APPLICATION FOR MODIFICATION ASSESSMENT REPORT

Application Number:	Mod2021/0023
----------------------------	--------------

Responsible Officer:	Catriona Shirley
Land to be developed (Address):	Lot 30 DP 2610, 38 Alma Street CLONTARF NSW 2093
Proposed Development:	Modification of Development Consent N164/10 granted for Alterations and additions to an existing dwelling including second storey addition extend basement level swimming pool double garage decks and landscaping
Zoning:	Manly LEP2013 - Land zoned R2 Low Density Residential
Development Permissible:	Yes
Existing Use Rights:	No
Consent Authority:	Northern Beaches Council
Land and Environment Court Action:	No
Owner:	Geoffrey Peter Kendall
Applicant:	Geoffrey Peter Kendall

Figure 1: Approved plans (N164/10/2) encroachment to be removed via condition shown in red

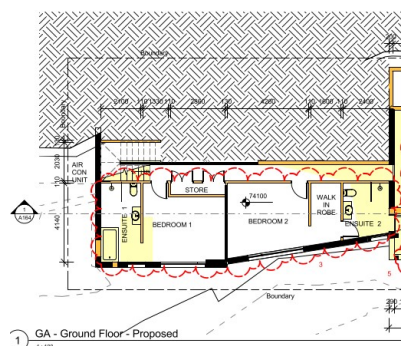
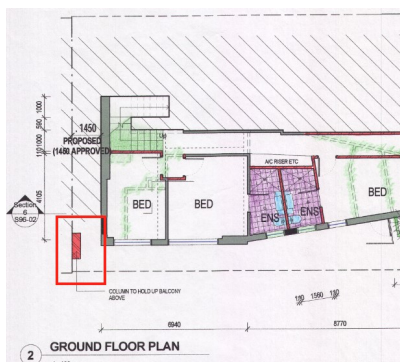
All encroachments of the existing dwelling at No.38 Alma Street, into No.29 Adelaide Street must be removed and the rear setback must be in accordance with the approved plans prior to the issue of the Occupation Certificate.

The encroachment in Figure 1 below (highlighted in red), has been removed from the approved plans as demonstrated in the submitted plans for MOD2021/0023, see Figure 2.

Figure 2: Submitted plans (Mod2021/0025) with no encroachment.

Figure 3: Original plans demonstrating W4.

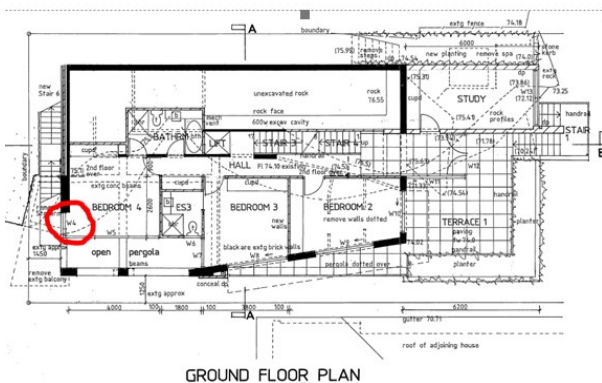
The northern window (W4) of bedroom 4 is to be glazed in translucent glass to a height of 1.65m above finished floor level and a 1.65m high visual privacy screen is to be provided to the northern end of balcony 1 for the first 2.0m from the external corner of the laundry, plans are to be suitably amended prior to issue of the Construction Certificate.

Window, W4 of bedroom 4 (highlighted in red below) existed only in the original version of the plans (25/5/2010) and was deleted on the subsequent modification plans dated 19/11/2014, however the condition had never been deleted despite the window not existing on the plans.

Condition ANS02 has been on the subsequent Modifications approval by error.

Figure 4: New glazed window within the south eastern corner as per condition

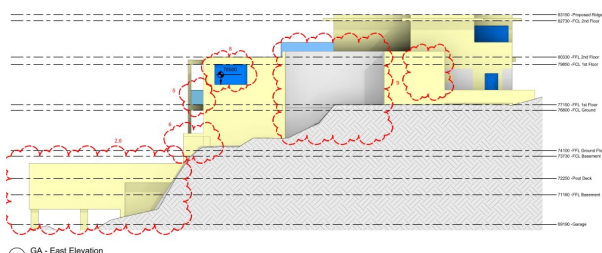
ANS03.1. The section of the building that contains the access stairs and associated walls located above R.L.77.15 (FFL) to the front of the first floor level to the South Eastern corner of the building is to be modified to comprise clear glazing above R.L.78.5. This should be designed to allow for views through this section of the building for the adjoining side window to the neighbouring property at No.34 Alma Street;

However, the proposal involves addition of a new clear window in the south east corner of the first floor as per condition ANS03.1. The glazing is clear to ensure satisfaction of the following requirements of the conditions *"The section of the building that contains the access stairs and associated walls located above R.L.77.15 (FFL) to the front of the first floor level to the South Eastern corner of the building is to be modified to comprise clear glazing above R.L.78.5. This should be designed to allow for views through this section of the building for the adjoining side window to the neighbouring property at No.34 Alma Street;"*. As a result the new window, while non-compliant with the required 3m setback, is located over a stairwell reducing privacy impacts, while satisfying the objectives of the condition.

Figure 5: Approved roof height within MOD2019/0542.

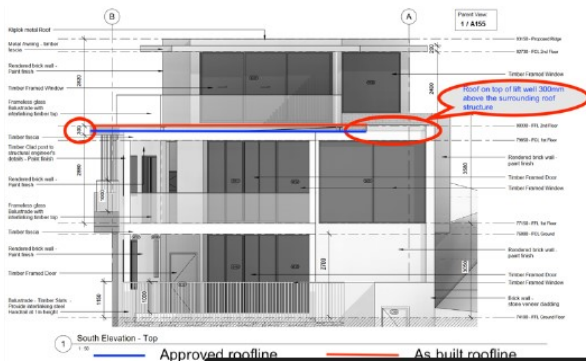
ANS03.2 The roofing above area described in 1. above is to be amended to include a flat (max. 5 degree pitch for drainage) roof not exceeding R.L.77.3;

The amendment to this conditioned to display a roof height of RL 80.0330 was approved in

MOD2019/0542, as demonstrated in figure 5 below.

Figure 6: Approved plans with no glazing. glazed balustrade to comply with condition.

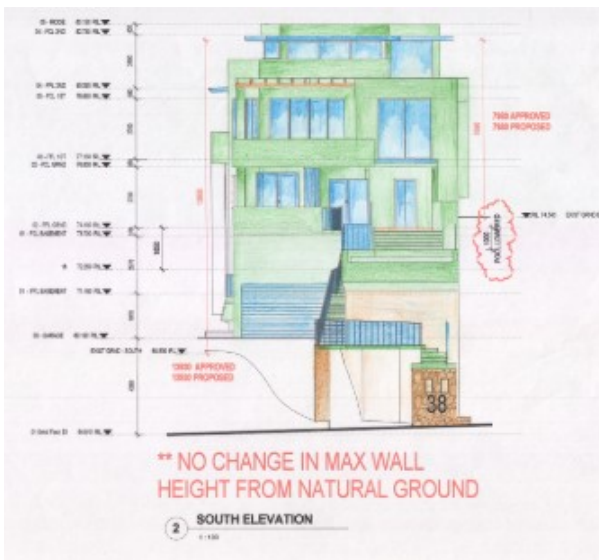
ANS 03.3. Clear glazed balustrade is to be included to the front terrace area at R.L.77.15 (first floor level);

Planter boxes have been removed and replaced with glass balustrading, see Figure 6 & 7.

Figure 7: Submitted plans demonstrating clear

Figure 8: Stairs to be removed shown in red. 72.25, removed stairs to comply with condition.

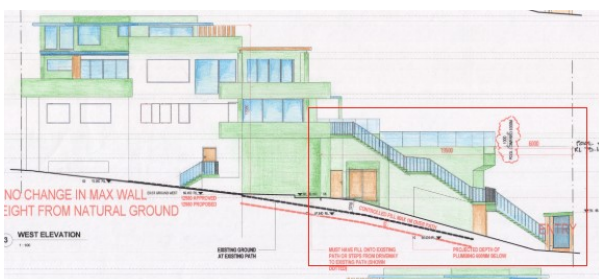
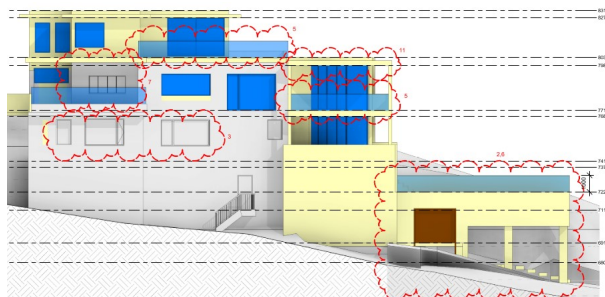
ANS03.4. The pool level is to be reduced from R.L.73.1 down to R.L.72.25 with the proposed external stairs leading to the dwelling to the western side of the building deleted from the scheme.

Figure 8 and 9 above demonstrate the entry arch removal to comply with the condition.

Figure 9: Submitted plans with the pool level at RL

Figure 10: Previous stairway highlighted in red.

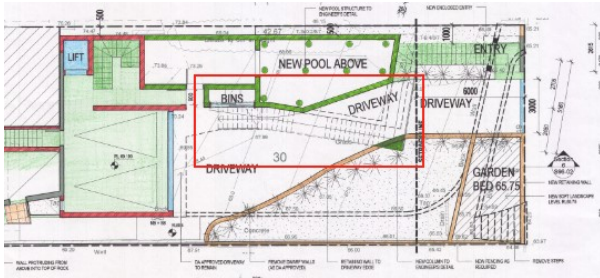
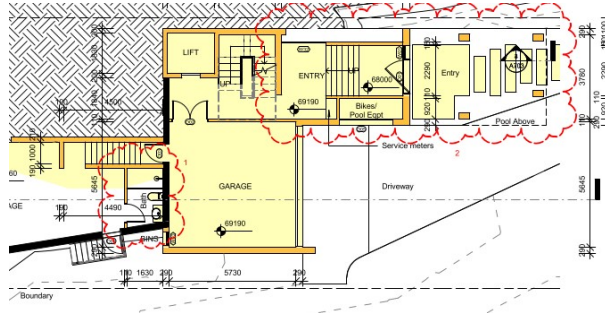
ANS03.5. A set of stairs leading to the entry level is to be configured leading to the entry level starting

from ground level below the front edge of the elevated pool leading from beneath the pool upwards to access the deck area.

Figure 11: Submitted plans with new stair design to comply with condition.

Figure 11: Front setback of the pool and associated structures 8.5m from the Alma Street front boundary.

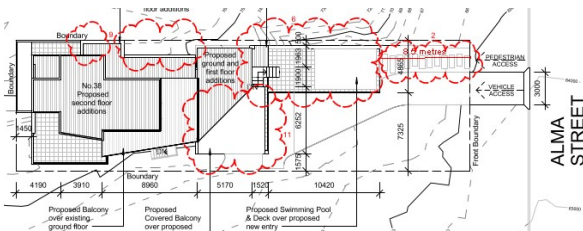
ANS 03.6. The pool and associated structures are to be located at least 8.5m from the front property boundary and relocated further into the site in a northerly direction to align with adjoining elevated pool to No.34 Alma Street;
